86100C-10B

S E R V I C E N O T E

86100C Digital Communications Analyzer

Low Voltage part loaded in 5 V application causes performance to degrade over time. Inspect for low voltage part and replace.

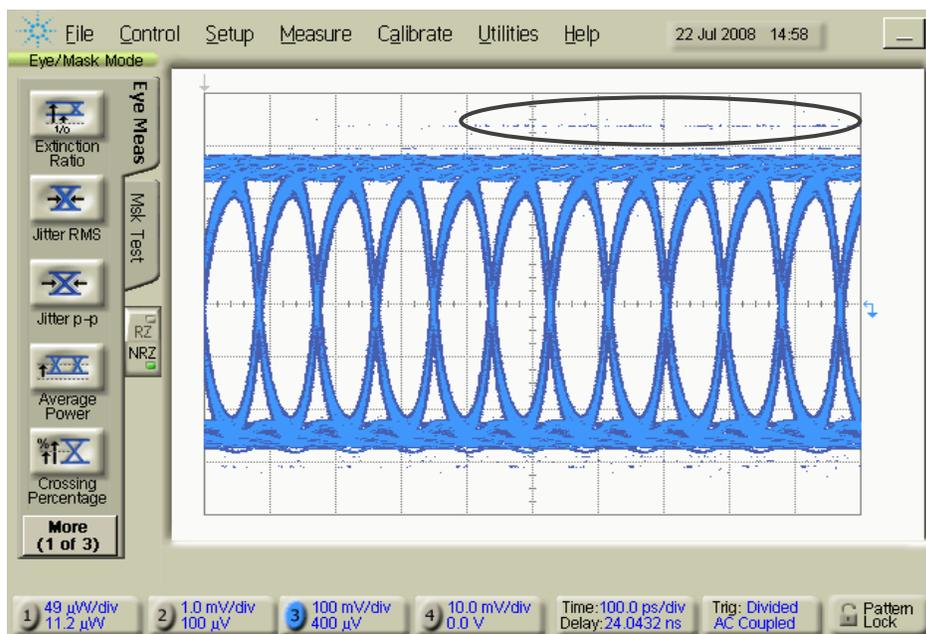
Inspect all 86100C's that come in to the service center that are within the serial number range listed and replace either U139 on the PCB or replace the entire assembly.

Refer to the attached picture for component location. It is labeled as LK TH MEMORY U139. All parts manufactured by and labeled Samsung are good. Parts manufactured by and labeled ISSI must be identified. The low voltage part number is IS61LV25616AL. These parts must be replaced with the 5 V part, part number IS61C25616AL.

Use a Metcal part SMTC-X148 to remove the part, and STTC-X44 to install the new IC. For the 500 series x=5, 600 series x=0, 700 series x=1, 800 series x=8

After the inspection or repair, perform the timebase adjustment and a complete calibration including all the verification tests and attach a label to the rear panel indicating "Service Note 86100C-10 Implemented".

Incorrect ISSI part:

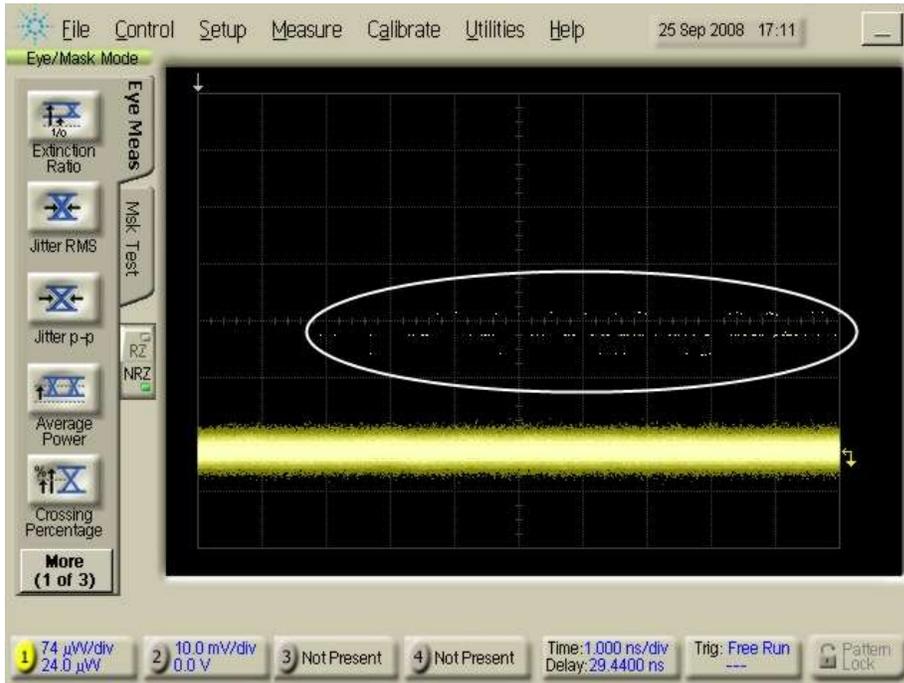
Example screen shots of the display of erroneous amplitude samples are included below.

Extraneous data:
